Docket Item #4
BAR CASE #2005-0256

BAR Meeting
January 18, 2005

ISSUE: Additions and Alterations

LOCATION: 519 South Lee Street

Figure 2 Current proposal for East elevation

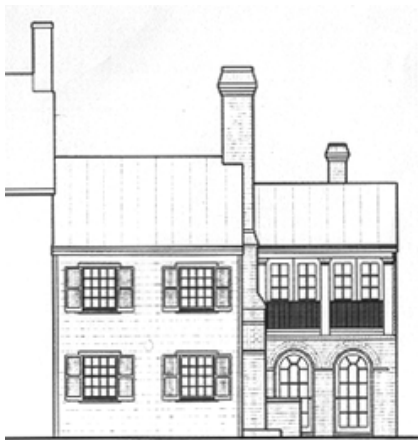
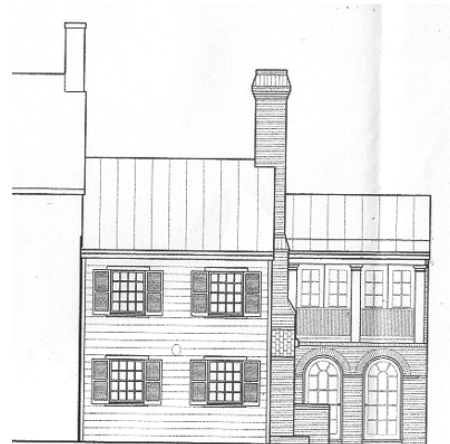
The existing side porch will be enclosed and an additional story added, with a balcony and railing. On the brick porch, new French-style doors will be placed within the existing arched openings. The new second floor will have Hardi-plank siding on the east elevation, with a “beaded smooth” finish. The second story addition will have a standing seam metal gabled roof, which will continue with the roof line of the new addition. On the north elevation, new brick on the ground level will match the existing brick in size, shape, color, texture, and bond pattern. Redwood or PVC trim supports and fascia are proposed for the balcony supports and railing. Two sets of double French-style doors will provide access to the new second level balcony. One new square window will be inserted on the east elevation between the balcony and the main section of the addition.

The applicant’s architect met with BAR Staff on two occasions to discuss the project prior to the November submittal, and again after the November meeting. After listening to Staffs’ and BAR comments, the applicant attempted to reduce the scale and mass of the new addition, so as to not visually overwhelm the rather small scale, historic two-story frame house. While Staff appreciates the efforts of the applicant and their architect, particularly in respect to reducing the height and footprint of the new addition, Staff is still concerned about the addition over the existing brick side porch and maintains that this addition increases the perception of more mass for the overall addition. While the height of the addition is less than the height of the main house and has been reduced since the November submittal, the footprint of the addition is more than half the size of the existing footprint of the historic house and side porch. Also, by adding a second-story to the existing brick side porch, the massing of the additions appears even more overwhelming from the vantage point of South Lee Street.

Figure 4 Currently proposed North elevation

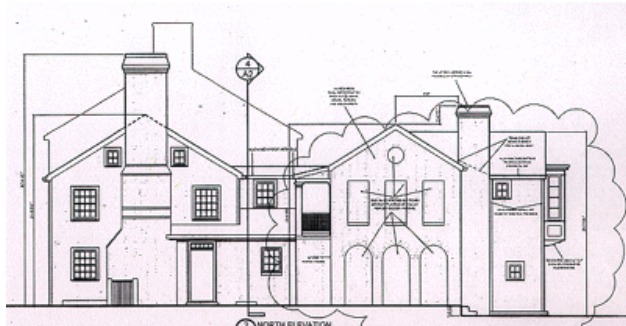
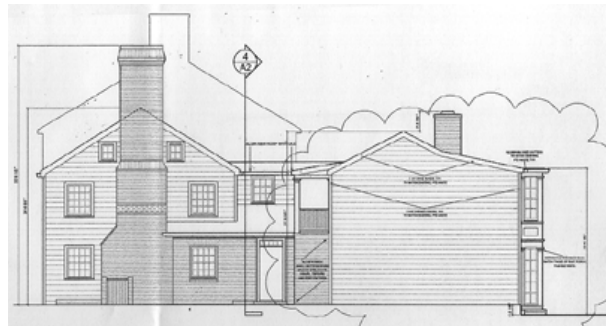
The addition will be constructed to the rear of the main section of the historic house, off a later addition with a shed roof. The addition will be 25' 2 1/2" wide, with a depth of 17' 5 7/8". This is a reduction in foot print from the prior submittal. The addition will have a height of 21' 8 5/8" to the peak of the gabled roof, almost 2' in reduction of height from the prior submittal. The addition’s standing seam metal roof will also expand to cover the second story addition over the existing brick porch. On the north side, the addition will be constructed to the property line, which is allowed under the zoning ordinance if a 5' side yard setback is maintained on the other property line. However, the addition does not maintain the 5' side yard setback on the south elevation due to the bump-out of the chimney.

Figure 5 Proposed South elevation

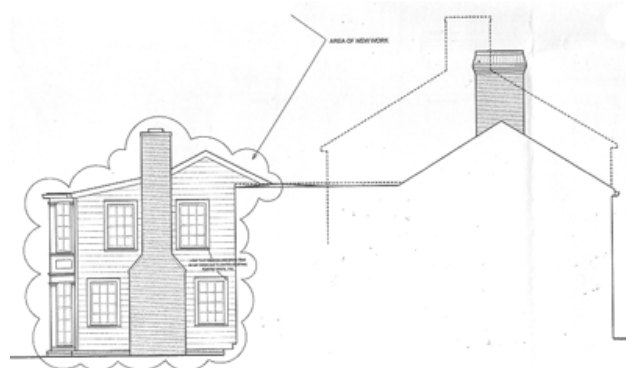
The proposed addition does not meet the zoning ordinance requirements as proposed. The chimney bump-out on the south elevation decreases the required 5' side yard setback. The 5' side yard setback must be maintained by the whole of the facade of the new addition. The subject property is zoned RM and is a lot of record as of February 10, 1953. Section 3-1108(C)(2) of the zoning ordinance states that any lot of record which is at least 25 feet but less than 35 feet wide is required one 5.00 feet side yard. Under the previous submittal, the applicant met this requirement on the south side of the property. However, with the chimney bump out, the requirement is not met on the south elevation. The applicant will need to eliminate the chimney bump-out on the south elevation or seek a variance.
